UNITED STATES PATENT AND TRADEMARK OFFICE

APPLICATION NO.	FILING DATE	FIRST NAMED INVENTOR	ATTORNEY DOCKET NO.	CONFIRMATION NO.
09/878,325	06/12/2001	Tsuyoshi Kitahara	Q64826	2121
7590 01/13/2004 SUGHRUE, MION, ZINN, MACPEAK & SEAS, PLLC 2100 Pennsylvania Avenue, NW Washington, DC 20037-3213			EXAMINER TRAN, LY T	
			ART UNIT 2853	PAPER NUMBER

Office Action Summary

DETAILED ACTION

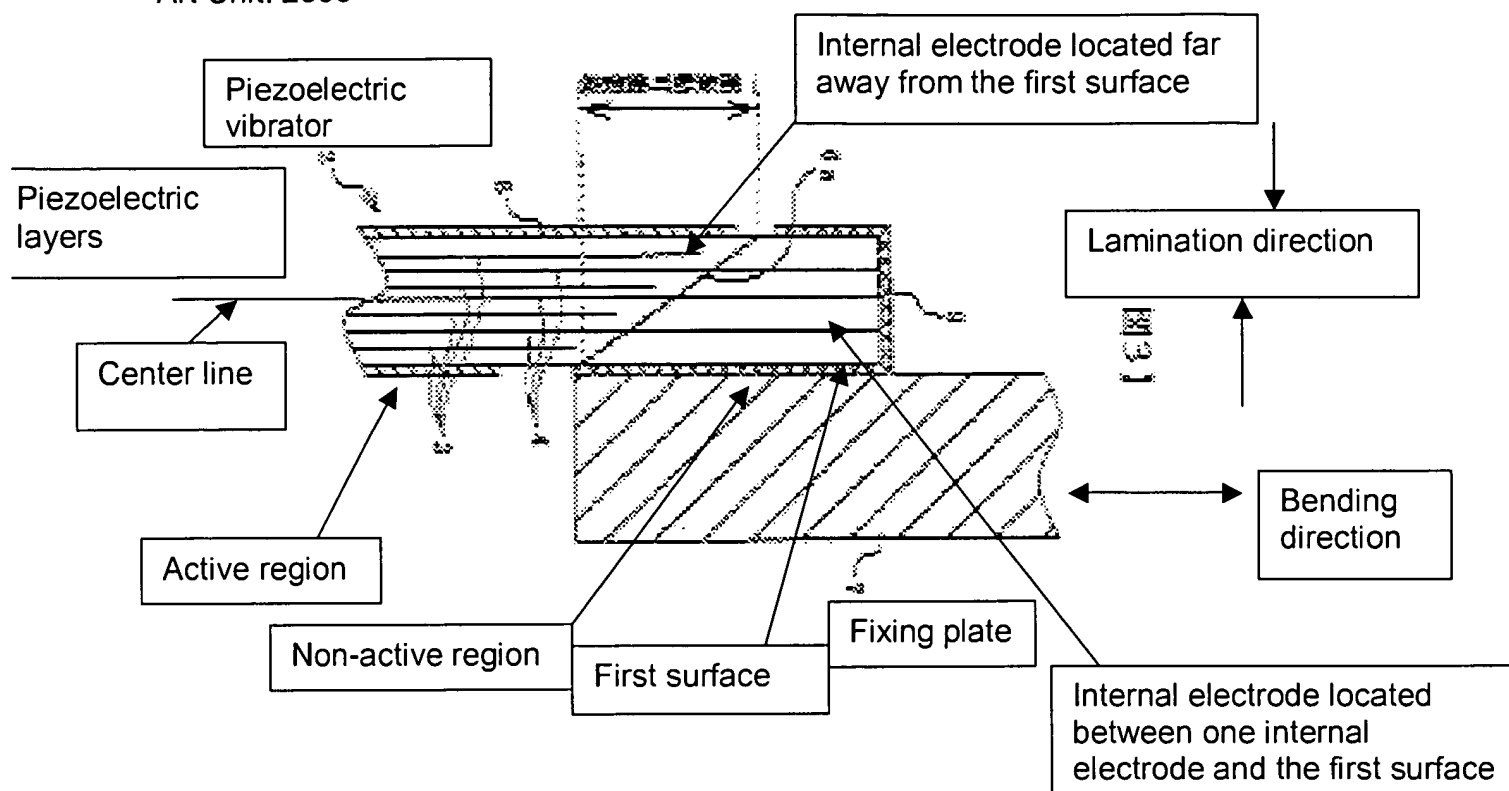
With respect to claim 13, Kitahara discloses a piezoelectric vibrator comprising:

At least one piezoelectric vibrator including:

- Common internal electrode layers (Fig.3: element 4) and segment internal electrode layers arranged alternately (Fig.3: element 3)
- Piezoelectric layers, each interposed between adjacent pair of the common and segment internal electrode layers (Fig.3)
- External electrodes formed on an exterior of the piezoelectric vibrator and electrically connected respectively to the common internal electrode layers and the segment internal electrode layers (Fig.3: element 9)
- A fixing member to which a surface of the piezoelectric vibrator is fixed (Fig.3: element 7)

- The piezoelectric vibrator is displaceable in a direction perpendicular to a lamination direction in which the internal electrode layers and piezoelectric layer are laminated (Fig.3)
- An electric field applied portion of at least one of the piezoelectric layers, located away from the surface fixed to the fixing member is shorter than other piezoelectric layers that are located between the at least one piezoelectric layer and the first surface (Fig.3)

With respect to claim 17, Kitahara discloses the piezoelectric vibrator further includes a non-active portion that is not expanded or contracted even when the piezoelectric layers in an active region are driven and the fixing member is joined to a side surface of the non-active portion (Fig.3).
